NOTICE TO CONSTRUCTION
APPROVED
12/30/2021
Harnett COUNTY
NORTH CAROLINA

Project No. 21-2054

Re: Structural Observation — 40 High Meadow Drive, Angier, NC 27501

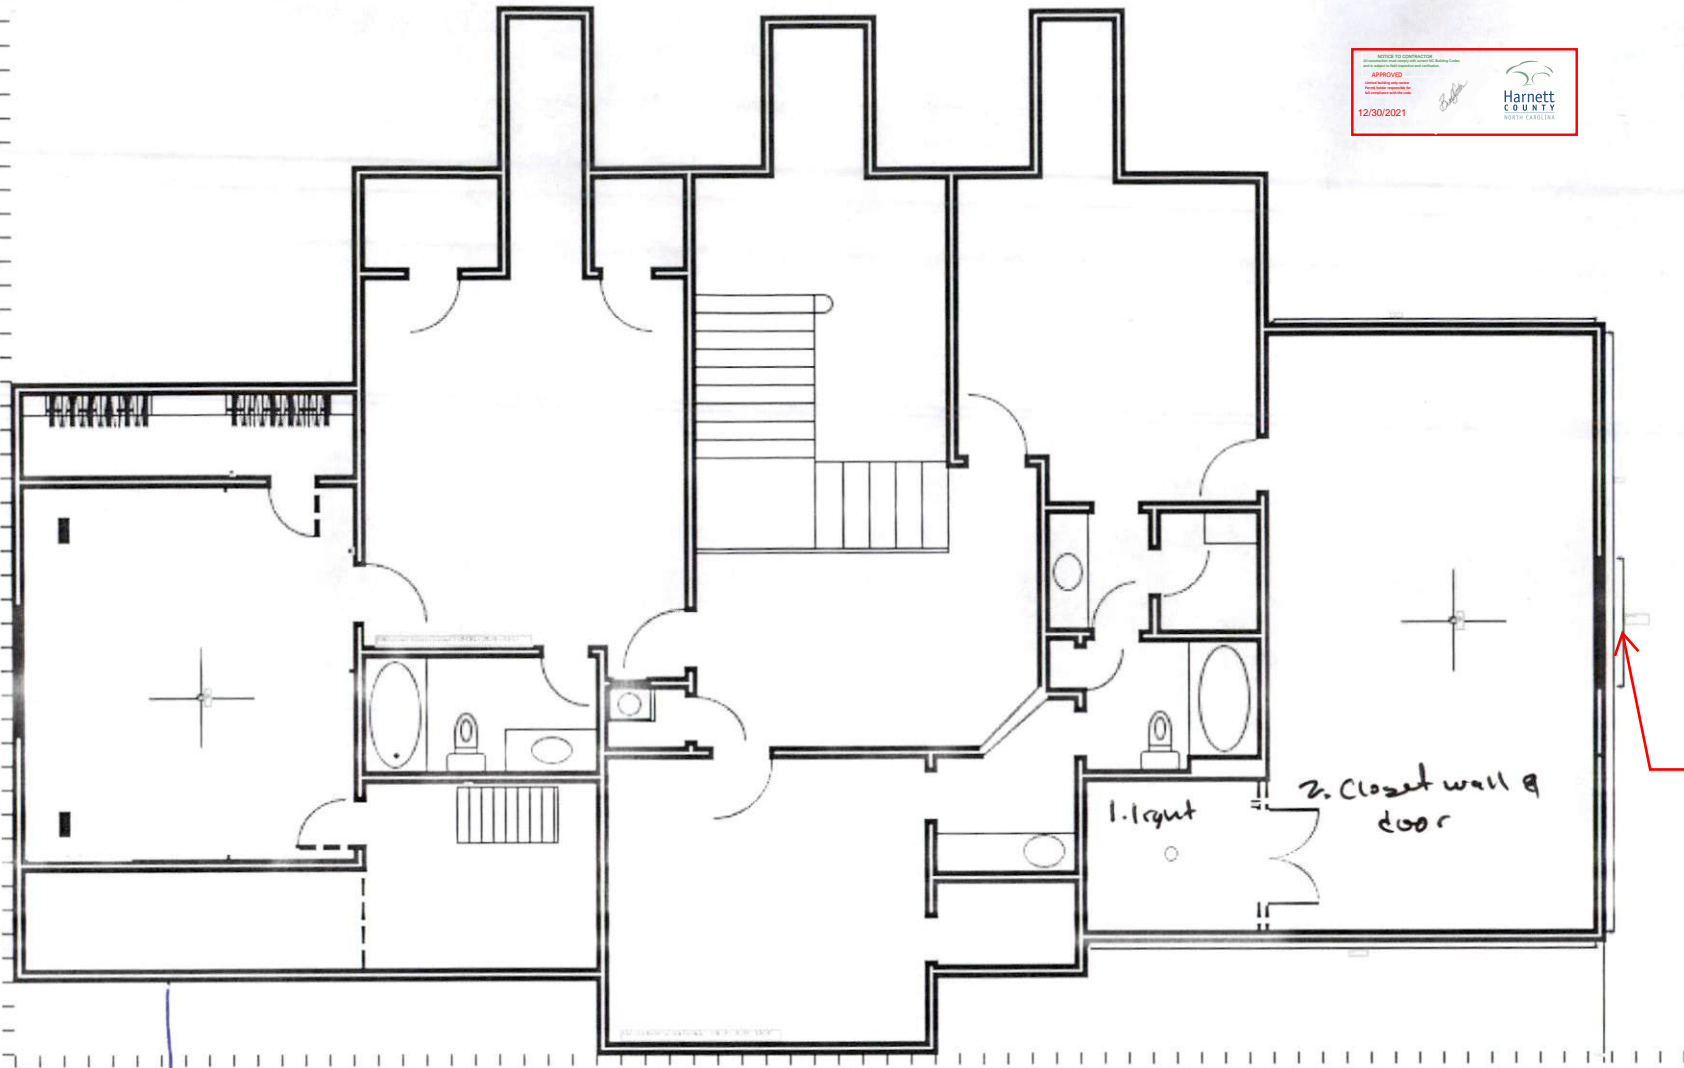
This window must meet egress

Finished room
See ERS letter
